From: Brenda Bernot <BBernot@wegopd.org>
Sent: Friday, June 16, 2023 4:58 PM
To: Mila Carter <lcarter@westtown.org>
Subject: RE: Fox Clearing, LLC - "Stokes Estate" Conditional Use Application - Reviews and PC meeting 6/21

RE: Conditional Use Application, Fox Clearing, LLC: Stokes Estate

Re: Stokes Estate (Fox Clearing, LLC)
Conditional Use - Traffic Review
Westtown Township, Chester County

RE: Stokes Estate
Conditional Use Review
Westtown Township
WTT-21-228

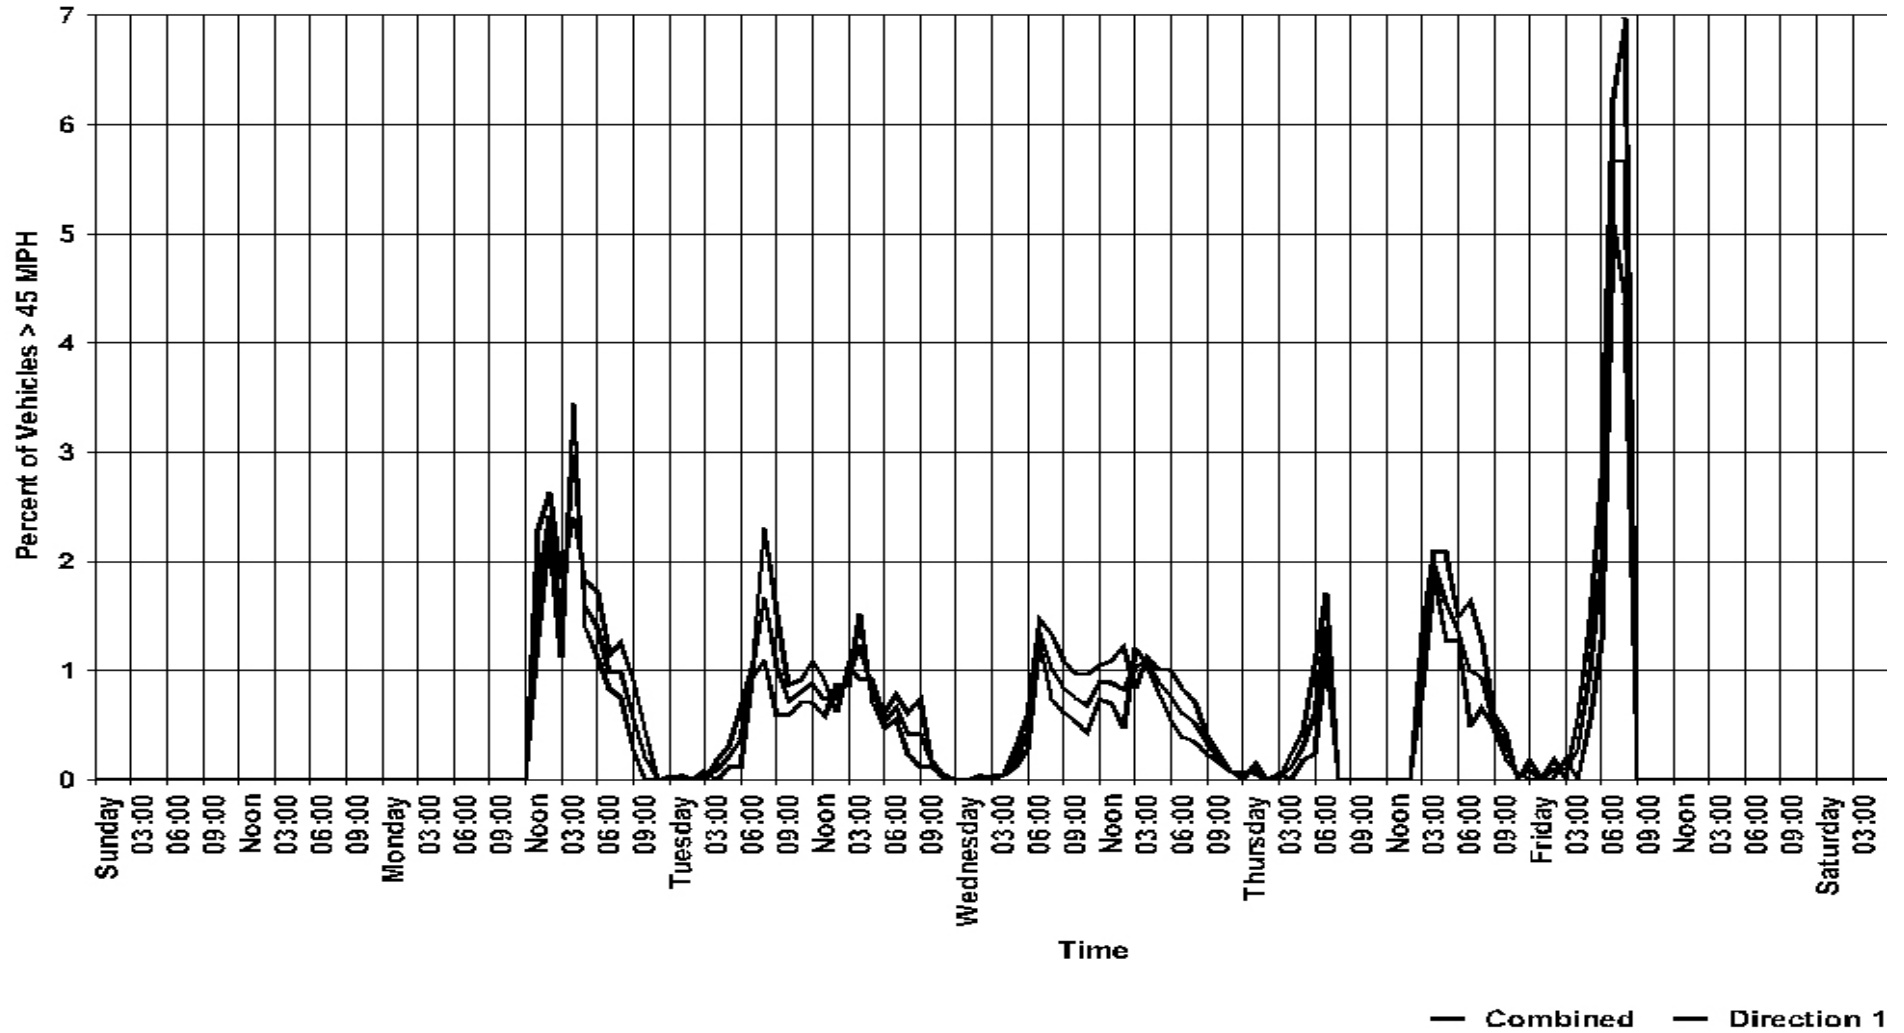
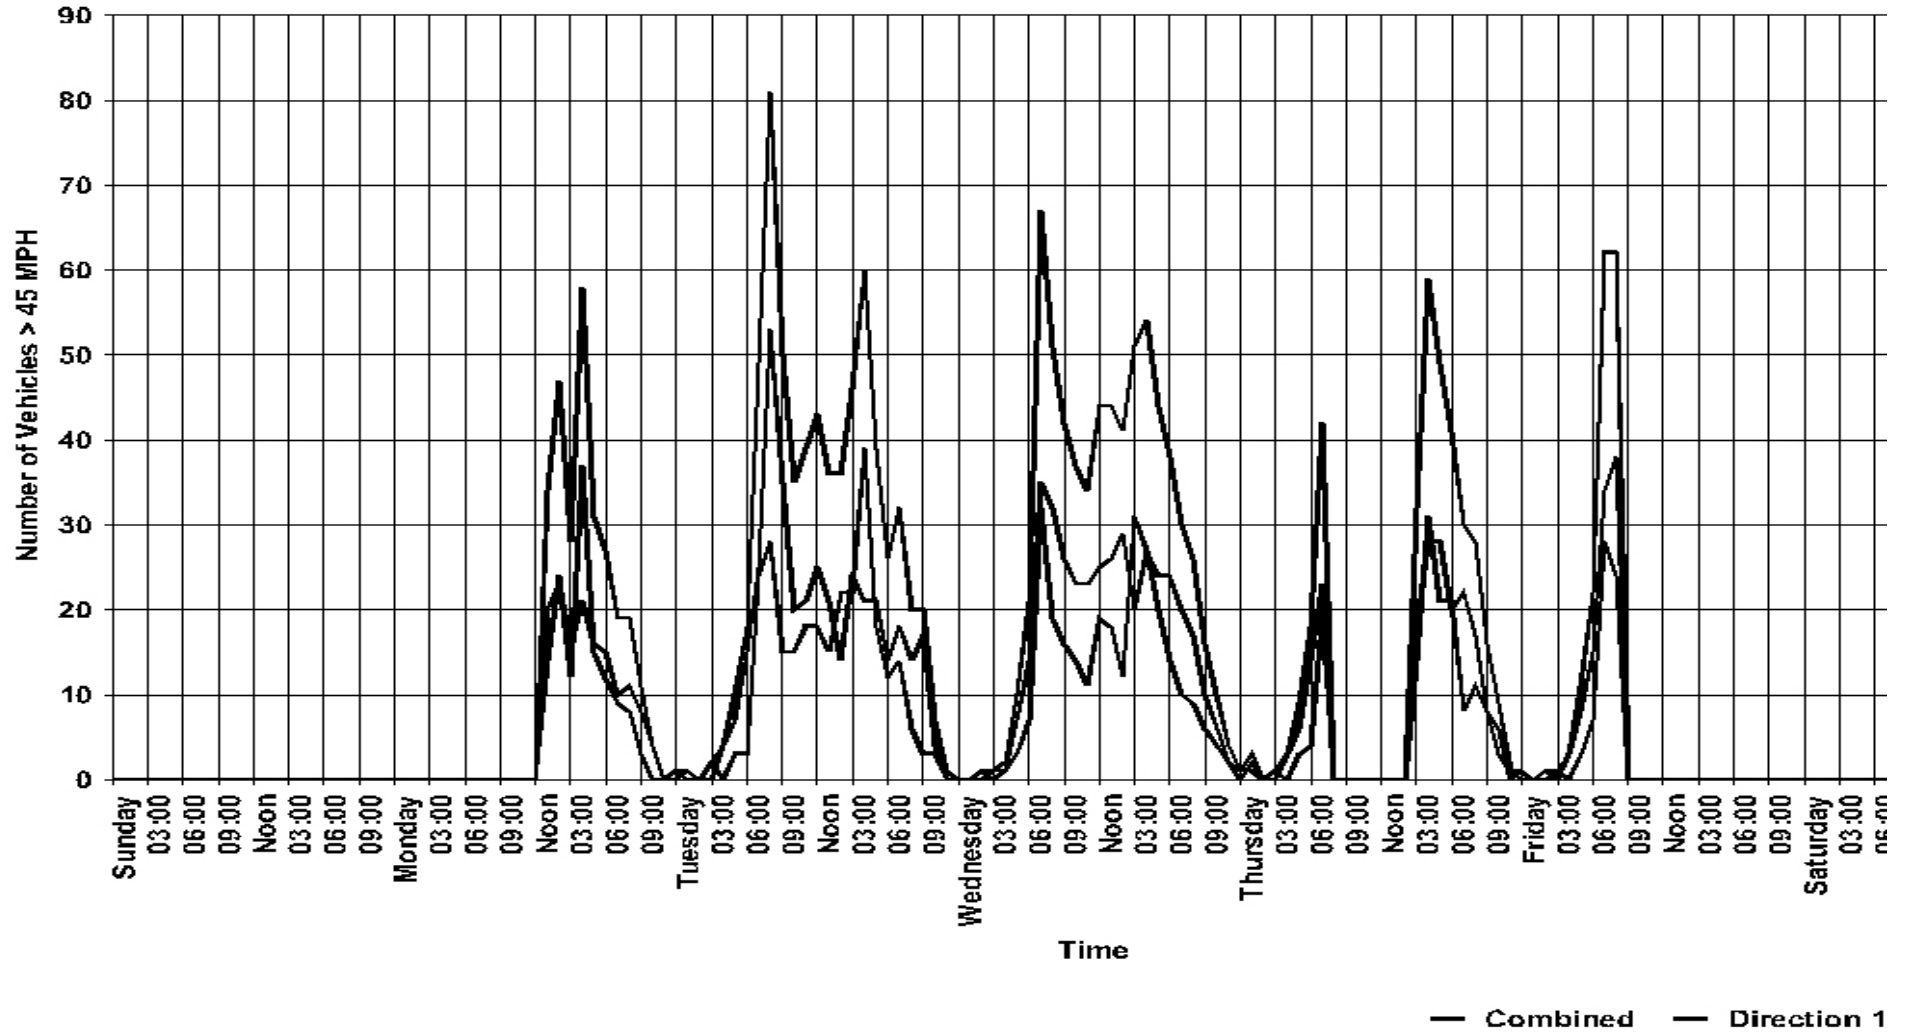
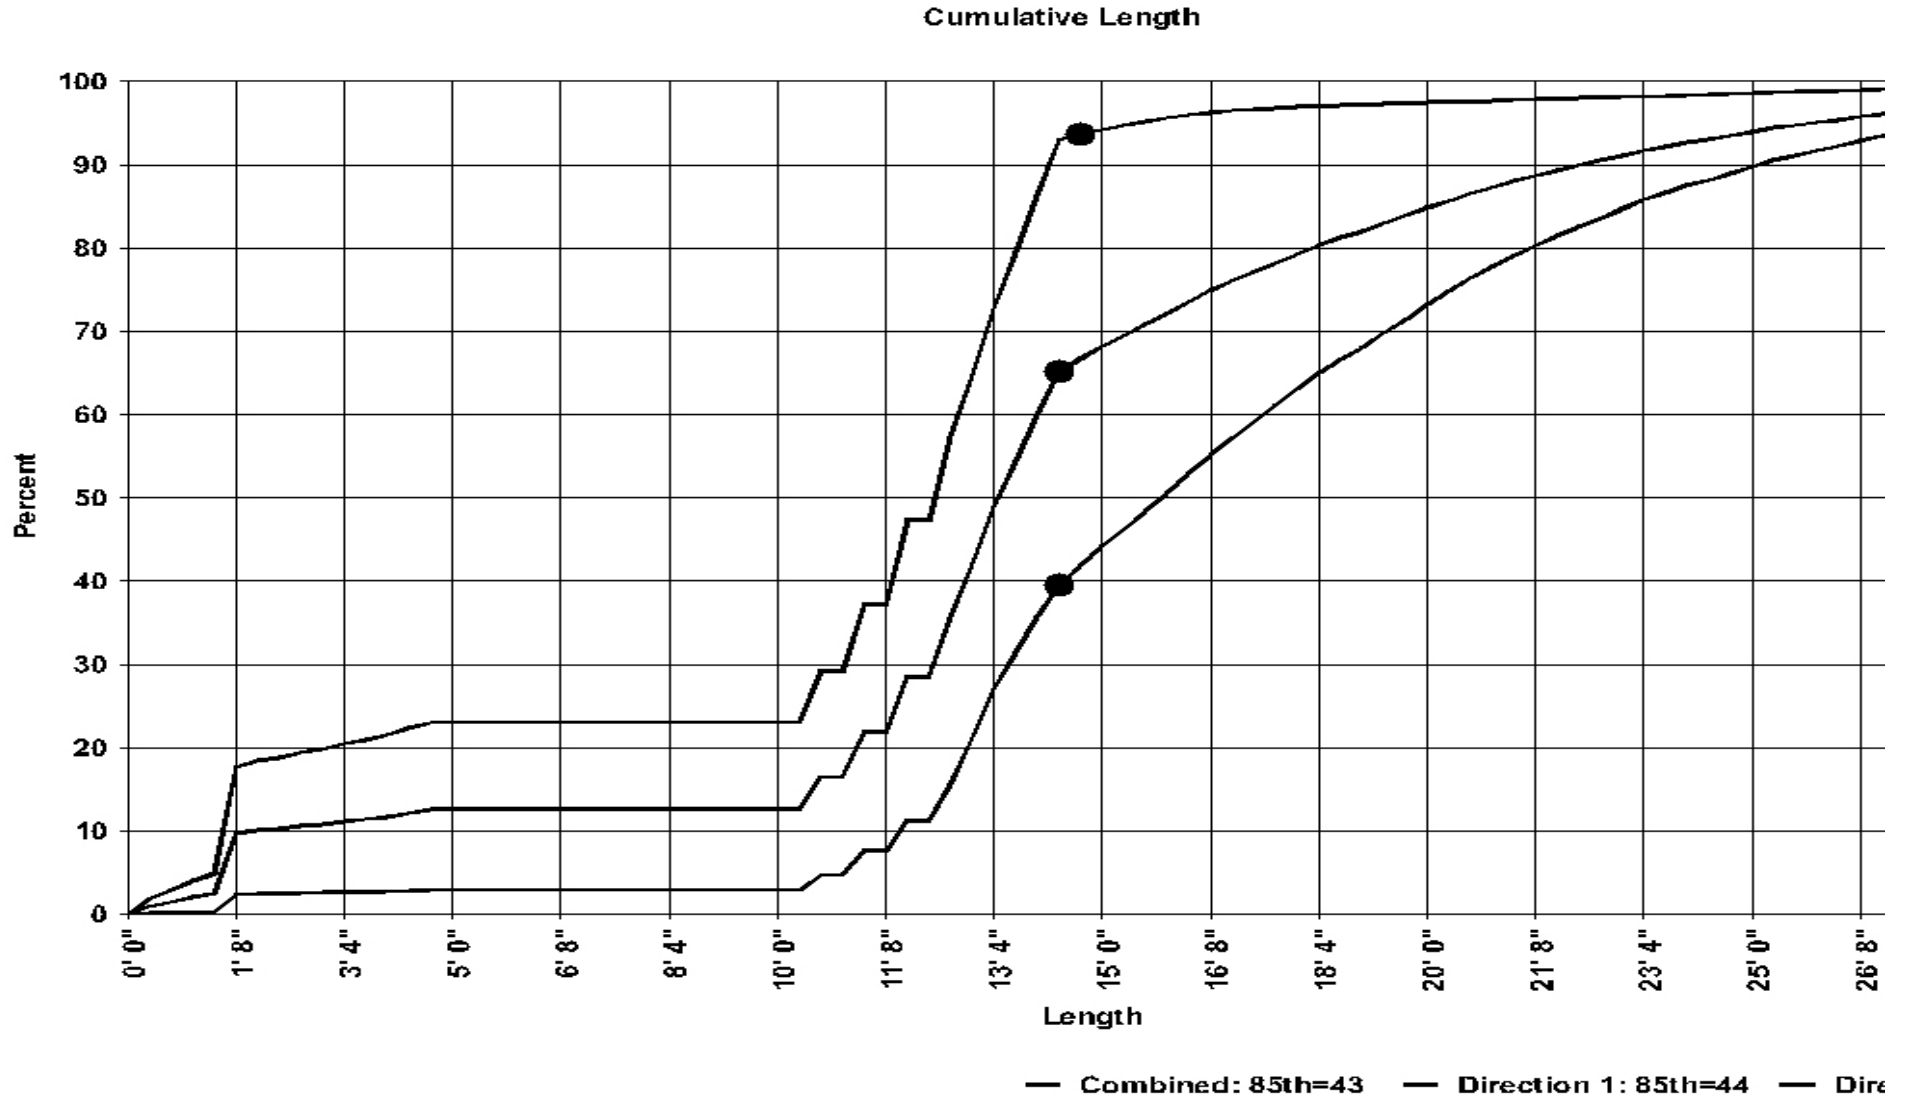
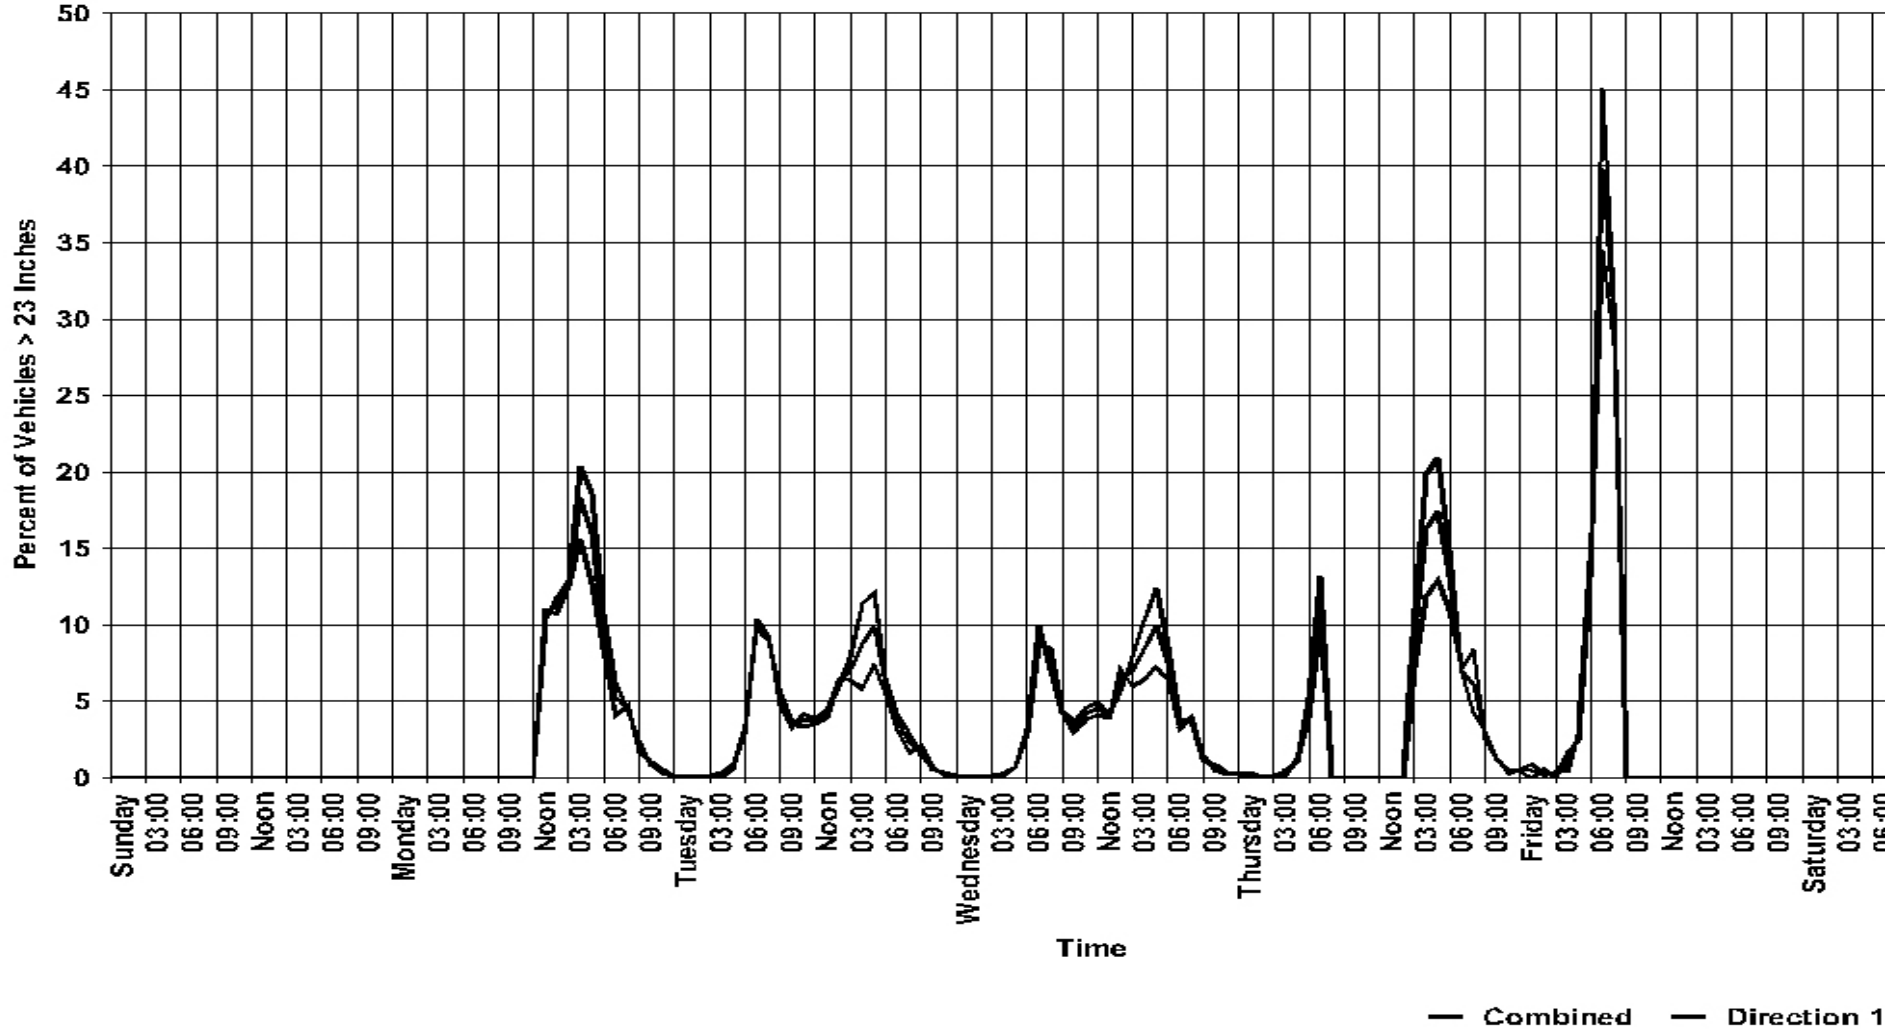
3. Although the data from the traffic study (2 attached files) is a little dated (from 2020), it clearly shows that 85th percentile for speed on Shiloh Road is between 43 and 44 mph (in a posted 30 mph zone). Additionally, the study indicated that there were a notable number of vehicles traveling between 51 and 60 mph, as well as a few vehicles traveling 61 mph or higher. Please have your traffic engineer review this data thoroughly, as we feel that speed is already an issue on this roadway. As a result, we conduct traffic enforcement on the roadway on a fairly consistent basis. If requested, we would be happy to conduct an updated traffic study on this roadway but we assume that your engineer may want to conduct their own.
